**Agenda Item 10**  
**Report PC21/22-11**

Report to	<b>Planning Committee</b>
Date	<b>9 September 2021</b>
By	<b>Director of Planning</b>
Title of Report	<b>Response to Rampion Extension Development Ltd's Section 42 Statutory Consultation on the Rampion 2 Offshore Wind Farm</b>
Purpose of Report	<b>To update Planning Committee on the SDNPA's draft Rampion 2 consultation response</b>

**Rampion Offshore Wind Farm  
Statutory Consultation – 14 July to 16 September 2021  
Section 42(1) (b) of the Planning Act 2008 and Regulation 13 of the Infrastructure  
Planning (Environmental Impact Assessment) Regulations 2017**

Fig. 1 – Seascape Character Zones; White Consultants; April 2021

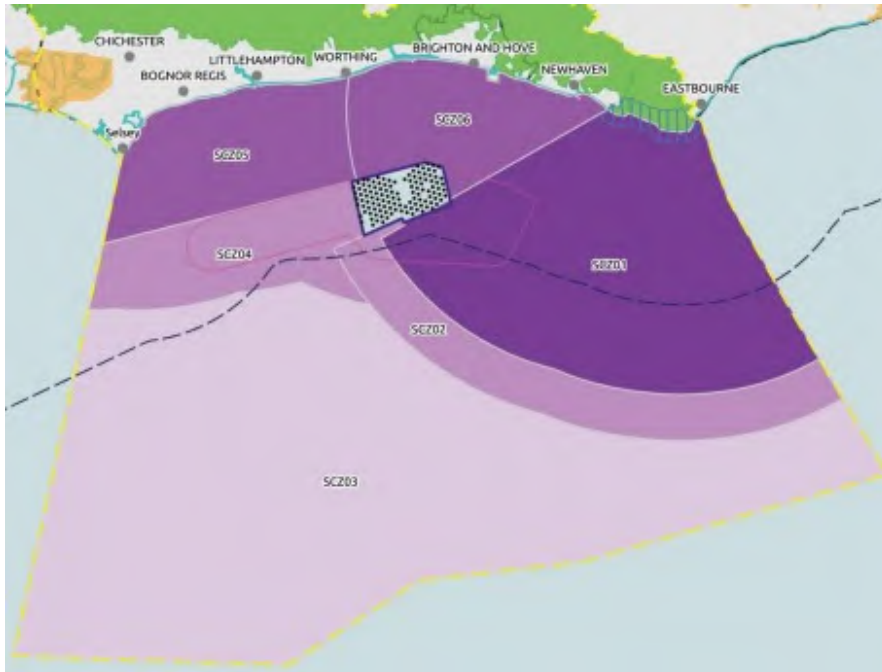
As you are already aware, the SDNPA has commissioned White Consultants (April 2021) to consider seascape character sensitivity with regard to views and the character of the seascape. The final report, which has previously been shared with RWE is included in **Appendix 3**. Based on this detailed analysis, 6 seascape character zones (SCZ) were identified, which were then used to identify the sensitivity to offshore windfarm development. Key findings from this assessment were that the SCZ east of the existing Rampion 1 array was highly sensitive and turbines of any height should not be installed in this area (see fig.1). There was medium sensitivity found in the SCZ west of the existing array and therefore further turbines should not exceed 225m in height.

We therefore continue to object to the extent of the application boundary, particularly as it extends to the east of the existing array and believe the maximum design scenario should reduce the height of the turbines to 225m.

Rampion 2 Offshore Wind Farm  
Figure 16.4 Seascape character  
Preliminary Environmental Information Report

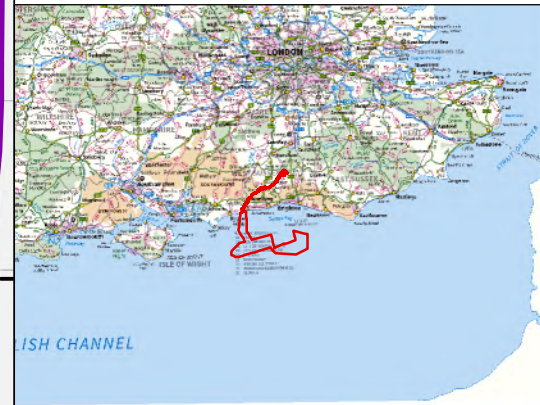
- 3.2. It is important to note, as the SDNPA, 2021 report states, that, in designating the area, the Inspector left the maritime boundary of the National Park open. In our view the SDNPA, 2021 report seascape zone boundaries (especially SCZ01) better reflect this sentiment in considering wind turbine development than the boundaries of MCA 08 (which do not reflect static features on the sea surface or the boundaries of likely visibility of structures). Nevertheless it is recognised MCA 08 is a valid receptor to consider as part of the Marine Plan evidence base.

**Figure 8**  
**Seascape sensitivity to offshore wind farms**

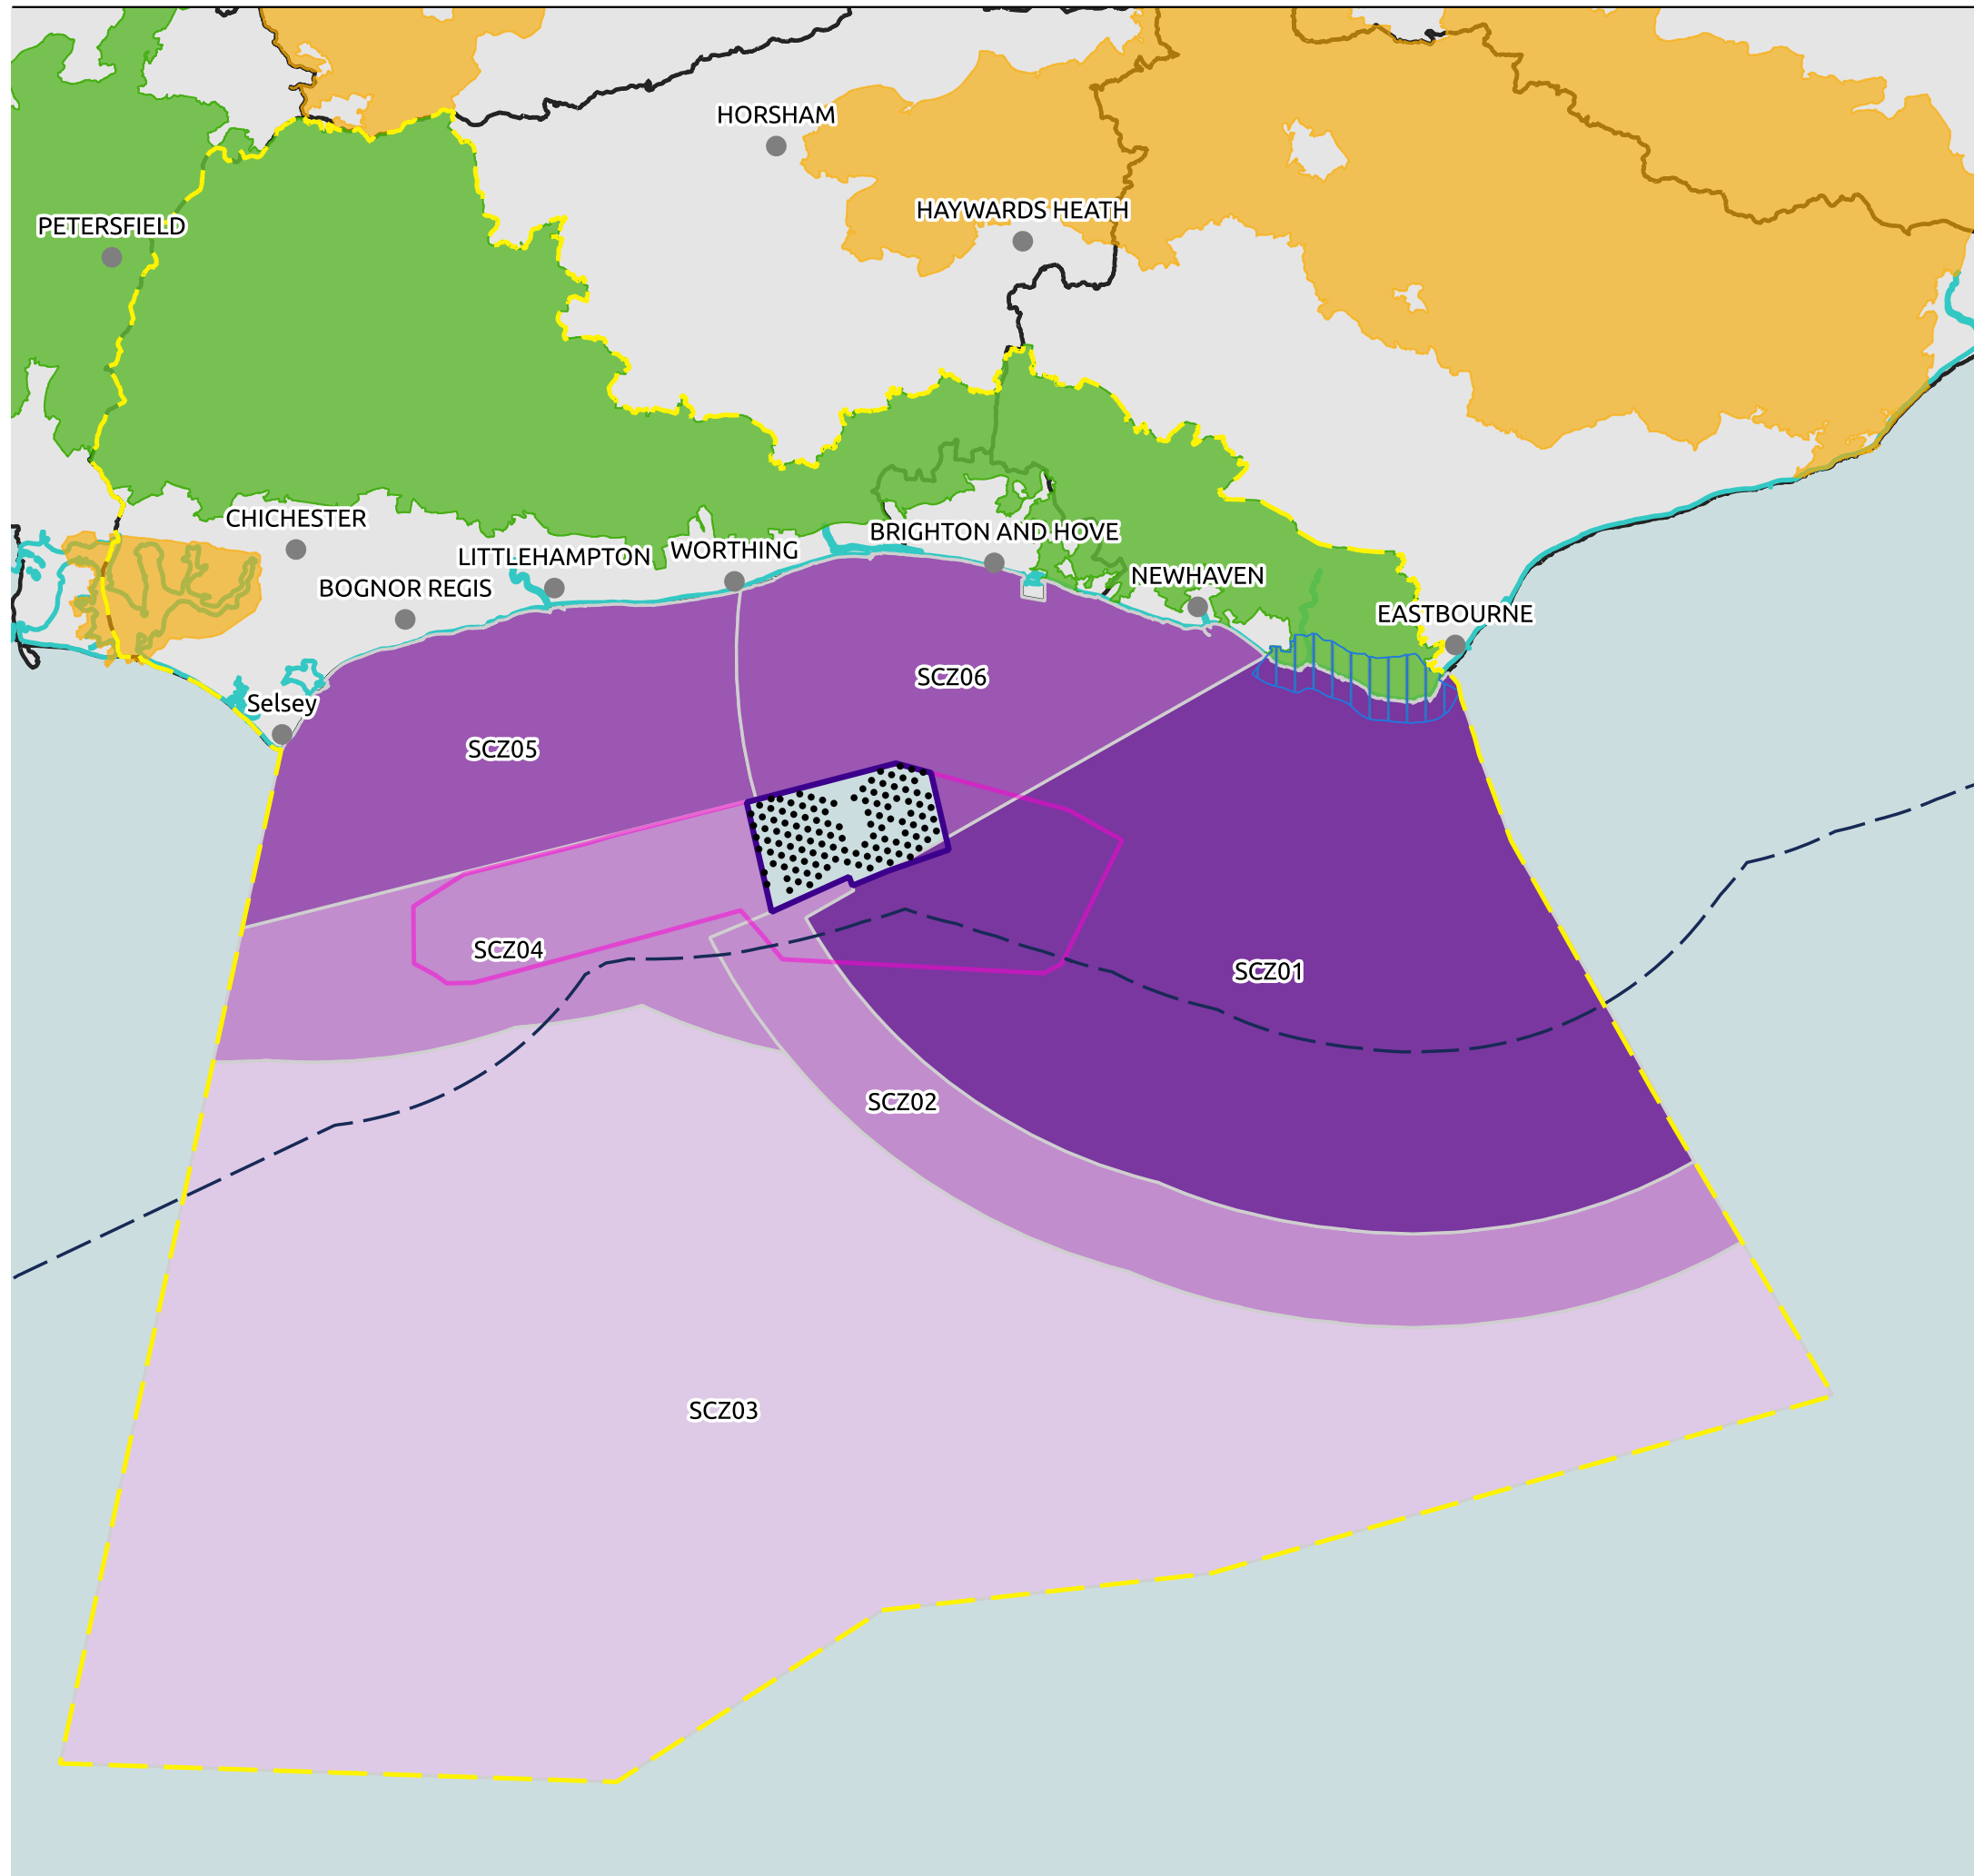
Seascape receptors	Sensitivity	Nature of effect	This report preliminary summary assessment comments
SCZ01	High	Negative	<p>Magnitude of change- the proposals extend into the area some way and are much closer to the National Park/Heritage Coast covering an area of open sea and skyline, reducing openness and adversely affecting the unspoilt character of the seas east of Rampion 1. The proposals are <i>at least</i> prominent when viewed from the National Park/Heritage Coast and would be seen on more days a year than Rampion 1. They detract from the breathtaking panoramic views from the distinctive coast including the South Down’s Way and Beachy Head, and they interrupt and reduce the strong sense of tranquillity and wildness which the seascape contributes to the coast. These factors relate to the National Park’s special qualities. They extend the spread of turbines of Rampion 1 and contrast in scale and spacing forming an awkward juxtaposition of structures. Though there is shipping and some leisure use within the area this is transitory and at a smaller scale, shipping passing some way offshore and there are a limited number of detractors and lighting both along the coast and offshore. Seascape effects are likely to be at the high end of the scale.</p> <p>Significance- it would be expected that the effects would be significant at the high end of the scale.</p>

SCZ02	Medium	Negative	<p>Magnitude of change- the proposals form a small part of the area adjacent to Rampion 1 and lie 30-37km from the combined National Park/Heritage Coast and 24km average from the edge of the SDNP to the north. The area contributes to an extent to the National Park’s setting but the proposed turbines would be visible and apparent behind the existing array although are contrasting in scale and spacing forming an awkward juxtaposition of structures. This contrast increases the magnitude of effect. Seascape effects are likely to be at the lower end of the scale.</p> <p>Significance- it would be expected that the effects would not be considered significant although the relationship between the proposed and existing turbines is visually conflicting.</p>
SCZ04	Medium	Negative	<p>Magnitude of change- the proposals extend substantially into the area and are visible in elevated views from the ridges in the hinterland out to sea including views from the South Downs Way and Monarchs Way, mainly across the open sea west of Rampion 1. The turbines cover a large area of open sea and skyline and are between noticeable and prominent when viewed from the National Park to the north due to the width of horizon affected. They substantially reduce the undeveloped nature of the zone which acts as part of the setting of the National Park and reinforces the sense of tranquillity of the ridge tops where there are limited views of development on the coastal plain, which relates to the National Park’s special qualities. The proposals extend and contrast in scale and spacing with Rampion 1 adjacent to the east forming an awkward juxtaposition of</p>

<p>structures. Though there is shipping and some leisure use this is transitory and at a smaller scale. Seascape effects are likely to be at the higher end of the scale.</p> <p>Significance- it would be expected that the effects would be considered significant.</p>
<b>Seascape receptors</b>	<b>Sensitivity</b>	<b>Nature of effect</b>	
SCZ05	High/medium	Negative	<p>Magnitude of change- the proposals lie directly to the south and are visible in elevated views from the ridges in the hinterland out to sea including views from the South Downs Way and Monarchs Way, mainly across the open sea west of Rampion 1. The turbines cover a large area of open sea and skyline to the south and are between noticeable and prominent when viewed from the National Park to the north. Due to their size and scale they substantially reduce the undeveloped character of the zone which acts as part of the setting of the National Park and reinforces the sense of tranquillity of the ridge tops where there are limited views of development on the coastal plain, which relates to the National Park's special qualities. The proposals extend and contrast in scale and spacing with Rampion 1 adjacent forming an awkward juxtaposition of structures. Though there is shipping and some leisure use this is transitory and at a smaller scale. Seascape effects are likely to be at the higher end of the scale due to the scale and extent of turbines.</p> <p>Significance- it would be expected that the effects would be considered significant.</p>

SCZ06	High/medium	Negative	<p>Magnitude of change- the proposals form a relatively small part of the area adjacent to Rampion 1 but extend further to the east within the zone closer to the combined National Park/Heritage Coast and to the south and west of Rampion 1.</p> <p>The turbines would be seen in breathtaking views along the Heritage Coast in juxtaposition with the unspoilt cliffs including the iconic Seven Sisters and often with the developed coast hidden from view by landform within the National Park such as Seaford Head. Whilst in front of Rampion 1 they are contrasting in scale and spacing forming an awkward juxtaposition of structures and would be seen for more days of the year. This would further erode the strong sense of tranquillity, wildness and openness which the seascape setting contributes to the coast, all of which relate to the Natural Parks special qualities. The turbines would be between noticeable and prominent especially from the west of the Heritage Coast.</p> <p>When viewed from the north they would be seen extending Rampion 1 with contrasting scale and spacing and would be between noticeable and prominent. Though there is shipping and some leisure use this is transitory and at a smaller scale. The developed coast and coastal plain is apparent in some views (but not all) from the National Park to the west of the Heritage Coast and this, to an extent, modifies the relationship between the downs and the sea but there is a clear delineation with the sea itself which is open with no structures apart from Rampion 1 to the west. Seascape effects are likely to be at the higher end of the scale due to the scale of turbines. This contrast increases the magnitude of effect.</p> <p>Significance- it would be expected that the effects would be significant.</p>

- 4.5. Taking into account the PEIR including its visualisations with this response and the SDNPA, 2021 findings for each SCZ, it is recommended that development should only occur within the Extension Area west of Rampion 1 and that turbines should not exceed 225m to blade tip in height ie the smaller 210m turbine scenario would be most appropriate (see SDNPA, 2021). In addition, it is recommended that there is clear separation between Rampion 1 and 2 to minimise the horizontal extent of arrays east to west along the horizon and the turbine layout is designed in coherent blocks. It is considered that the full north to south extent of the extension area should be utilised to maximise the size of east/west gaps between the arrays.
